SERVICE LETTER

CABIN SEAT – 4 POINT RESTRAINT SYSTEM OPTION

MODELS AFFECTED: All MD900 helicopters that have the 3 point cabin seat restraint system installed.

Figure 1. Seat Modification for 4 Point Restraint System

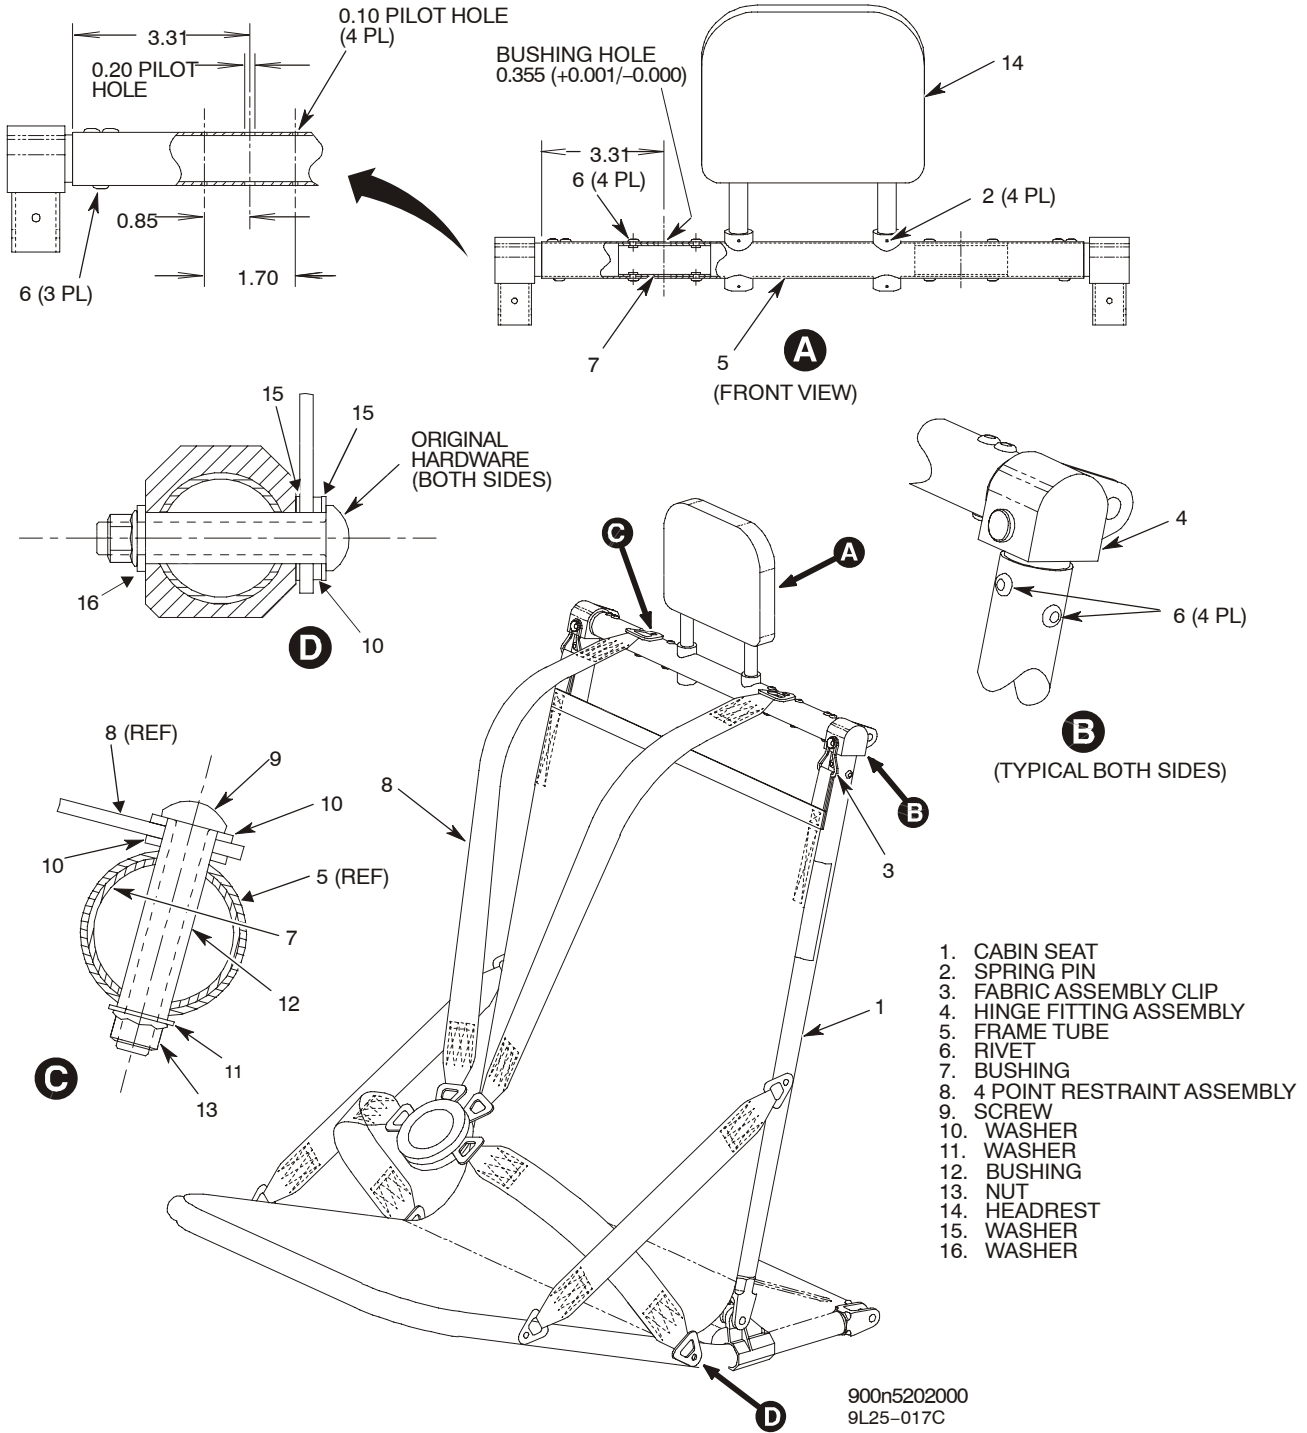
*MDHI has certified an upgraded 4 point cabin seat restraint system as a replacement to the 3 point system. The 900N3202141-101, -103, and -105 cabin seat can be changed to accept the new 4 point restraint. The four point restraint can be installed on the 900N3202141-107 cabin seat without change. New 4 point restraints (4-01-225501, 4-01-115501) are to be procured directly from the manufacturer, refer to Replacement Parts/Supplies.

- (3). Modify the 900N3202141-101, -103, -105 and -107 cabin seat as follows:

- (a). Disconnect fabric clips (3) from hinge fitting (4).

- (b). Remove rivets (6) from fittings (4).

- (c). Remove frame tube (5).

- (d). Remove rivets (6) from fitting (4) on right side of frame tube (5).

- (e). Remove fitting (4) on right side of frame tube (5).

- (f). Drill **0.20 in. (5.08 mm)** pilot hole for bushing (12) in frame tube (5).

- (g). Drill **0.10 in. (2.54 mm)** pilot holes for rivets (6) in frame tube (5).

- (h). Put bushing (7) in frame tube (5).

- (j). Drill four rivet holes, use a number 21 drill **0.159 in. (4.0386 mm)**.

- (k). Install rivets (6). Install wet with epoxy primer.

- (m). Drill a **0.355-0.356 in. (9.017-9.0424 mm)** hole through frame tube (5) and bushing (7).

- (n). Identify tube (5) as 900N5202000-3.

- (p). Install rivets (6). Install wet with epoxy primer.
- (q). Install fabric clips (3) on fittings (4).
- (r). If removed, install headrest (14). Use new spring pins (2).
- (4). Install new restraint (8) on seat frame.
 - (a). Install Upper attachments hardware. Ref Figure 1 detail C
 - (b). Install Lower attachments hardware. Ref Figure 1 detail D
 - (c). Torque Nuts (Ref. CSP-SPM, Section 20-10-00)
- (5). Identify seat (1) as 900N5202000-103 adjacent to name plate.
- (6). Install cabin seat (Ref. CSP-900RMM-2, Section 25-20-00).
